**SOLICITATION AMENDMENT
MODIFICATION DE L'INVITATION**

Title - Sujet Boat Grid Remediation	
Solicitation No. - N° de l'invitation F1571-208002/A	Amendment No. - N° modif. 002
Client Reference No. - N° de référence du client	Date 2020-07-06
GETS Reference No. - N° de référence de SEAG PW-\$PWY-036-8786	
File No. - N° de dossier PWY-0-43013 (036)	CCC No./N° CCC - FMS No./N° VME
Solicitation Closes - L'invitation prend fin at - à 02:00 PM on - le 2020-07-17	Time Zone Fuseau horaire Pacific Daylight Saving Time PDT
F.O.B. - F.A.B. Plant-Usine: <input type="checkbox"/> Destination: <input checked="" type="checkbox"/> Other-Autre: <input type="checkbox"/>	
Address Enquiries to: - Adresser toutes questions à: Martin (PWY), Delia	Buyer Id - Id de l'acheteur pwy036
Telephone No. - N° de téléphone (778) 707-2139 ()	FAX No. - N° de FAX (604) 775-6633
Destination - of Goods, Services, and Construction: Destination - des biens, services et construction: DFO - Porpoise Bay - Sechelt, BC

Boat Grid Remediation – Fisheries and Oceans Canada

Porpoise Bay Government Wharf - Sechelt, BC

AERIAL OVERLAY OF SCH PORPOISE BAY

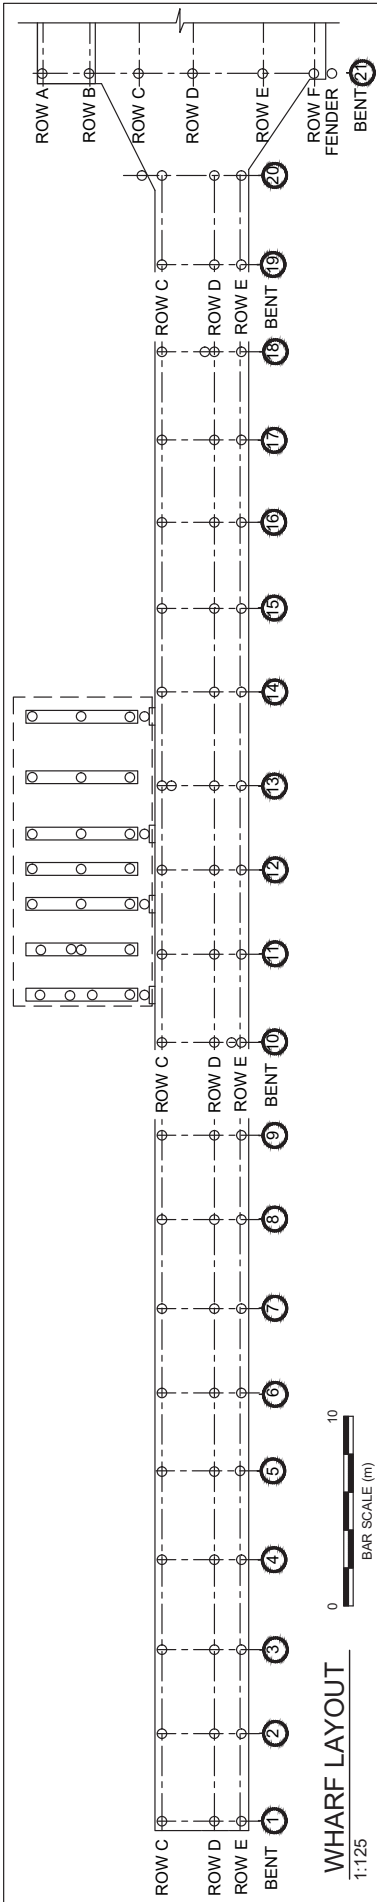
QUESTION 22: As per the specifications: "The Contractor shall not enter on nor occupy with men, tools, equipment or material, any ground outside the property of the Harbour Authority without the written consent of the party owning such ground".

Can a map be supplied indicating the boundaries of the Harbour Authorities' property, exclusion zones within the harbour, etcetera.

ANSWER 22: Yes, please see the Aerial Overlay attached

Client:  Fisheries and Oceans Small Craft Harbours Branch	Drawing Title: WHARF AND FLOAT REPAIRS PORPOISE BAY SMALL CRAFT HARBOUR BOAT GRID LAYOUT		Draftsman: -	Scale: NTS
			Date: JULY 2020	DWG: PB-HR-008

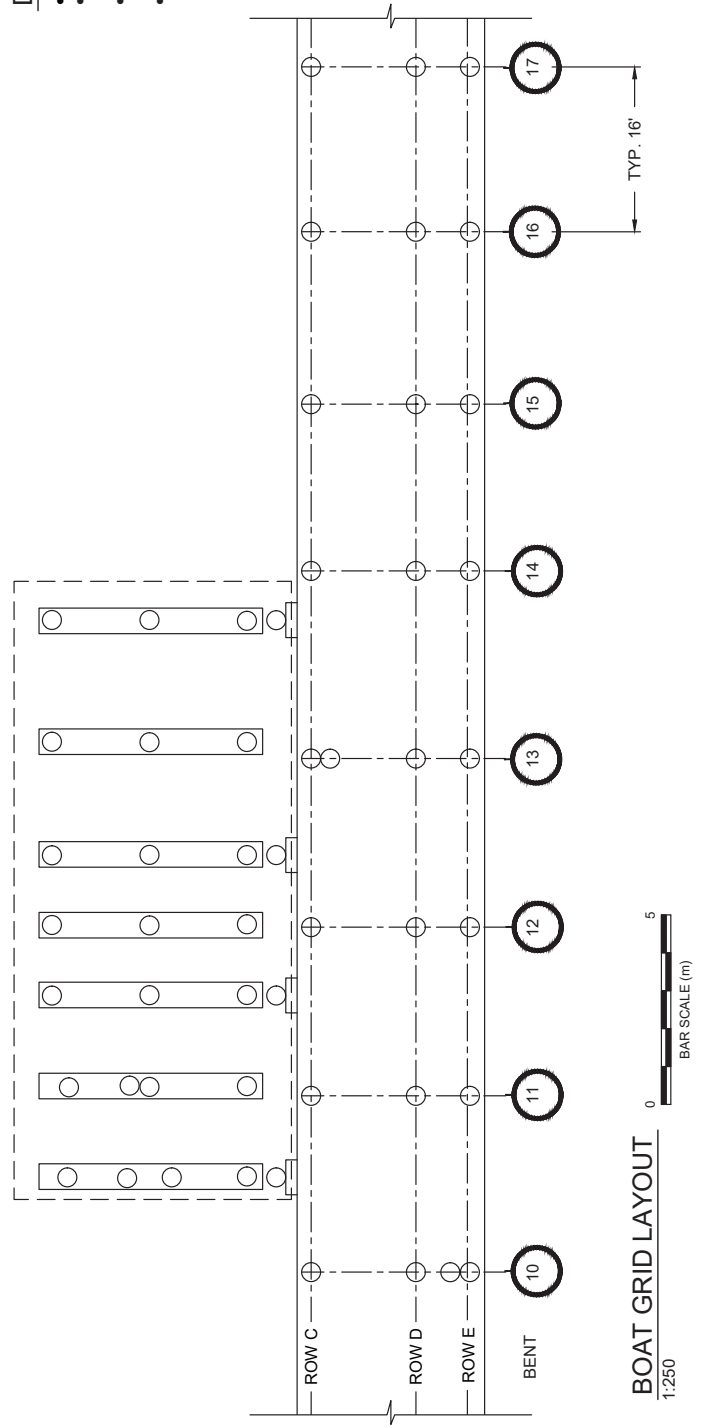
QUESTION 5: Can you provide information on the wharf weight capacity and dimensions?

ANSWER 5: Please see the dimensions on the attached site plan. The load limit as posted on site is the following:

MAX G.V.W.: 11,000 kg, for 3 axles

MAX G.V.W.: 6,000 kg, for 2 axles

Drawing Title: Cross Braces and Walers
PORPOISE BAY SMALL CRAFT HARBOUR

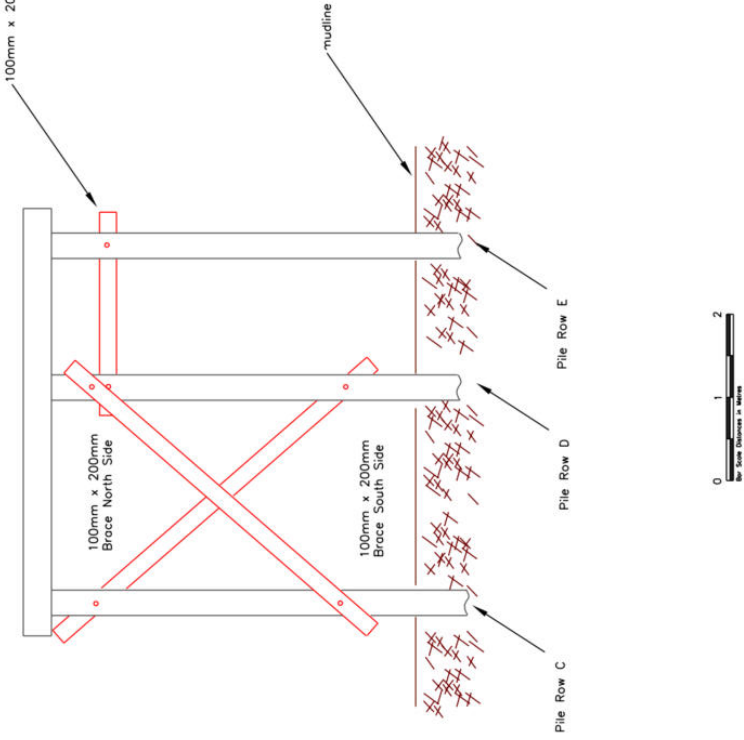
QUESTION 11: Section 35 20 23 Excavation/Dredging, Part 3.1.5 : *Contractor to determine suitable side slopes to avoid damaging or undermining adjacent eelgrass bed and wharf support piles. If the eelgrass bed is disturbed or impacted by the excavation works, side slopes or sediment control devices, the Contractor will be responsible for replanting the eelgrass at a ratio of 2:1. If support piles are damaged, the Contractor will be responsible for replacement or repair costs.*

Can a bracing plan for the approach be made available?

ANSWER 11: Please refer to the Porpoise Bay - Braces and Walers table attached as well as the drawing attached.
